Product: TCD 3004

Service Information

Click-noise at operation.

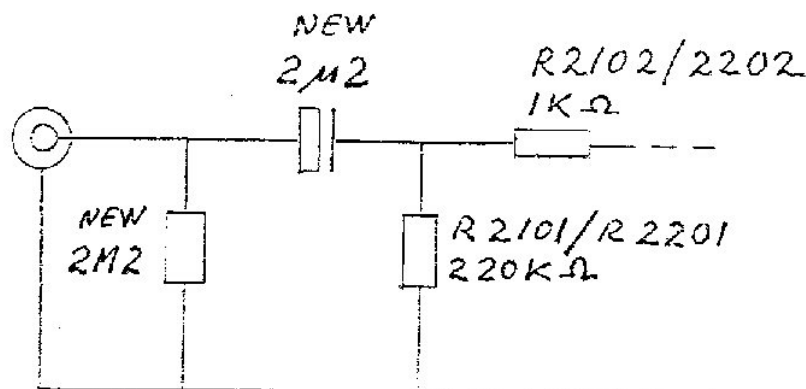
When connected to some types of preamps or receivers, click-noise may occur when some buttons on the preamp/receiver are operated.

This problem is solved by connecting a 2,2 micro farad electrolytic capacitor and a 2,2 megaohm resistor to the "record" cinch sockets as shown in the diagram:

This solution will be introduced on the production line in January 1982.

Part of assembly no. 9

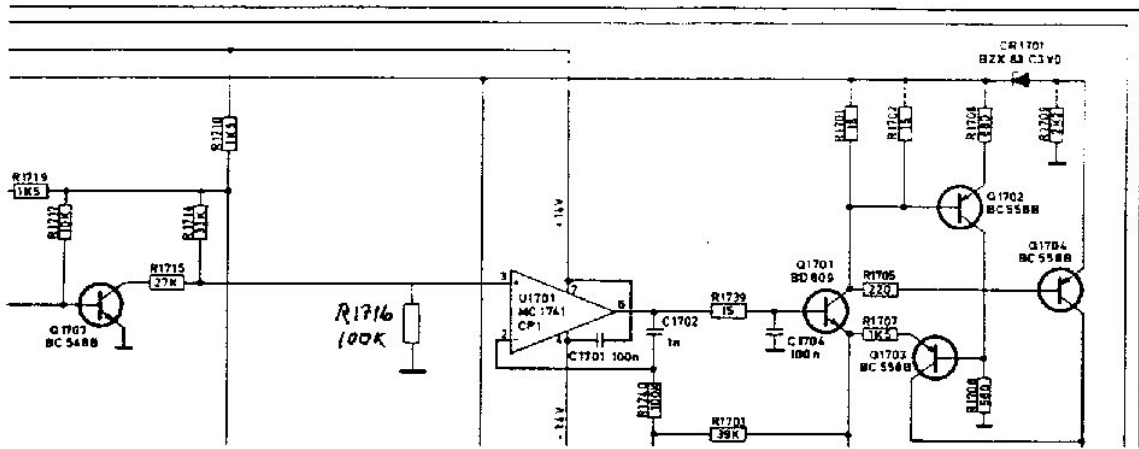
MODIFICATIONS.

From serial No. 16600 -	Symptom	Modification
200	Low frequency noise	A4 board: R732/R832, change to 680 kohm R733/R833, change to 1 kohm
350	Head bridge moves from release when power off.	A10 board: See processor diagram page 27. in the Service Manual. Additional circuit from serial No. 350
810	Intermittent Tape Counter 1)	A7 board: Replace the board with the new type.
893		New Dolby NR * circuits LM1111. The boards A1, A3 and A4 are replaced from the factory.
922	Reduce heat in the erase head 1)	A7 board: R1516 change to 560 ohm R1509/R1510 change to 120 ohm R1508/R1511 change to 4,7 kohm Oscillator voltage: Approx. 7V Oscillator frequency: 80-84 kHz.
	Reduce take-up tension 1)	A9 board: R1715 change to 47 kohm 2) R1716 change to 100 kohm Take-up tension: Approx. 60 gr/cm
1125	Distortion 2nd harmonic 1) Only from serial No. 893 to 1125	A1 board: C123/223 change to 47uF electrolytic A3 board: C518/C618 change to 47uF electrolytic

1) We recommend those changes to be done on all units at service.

2) See separate diagram
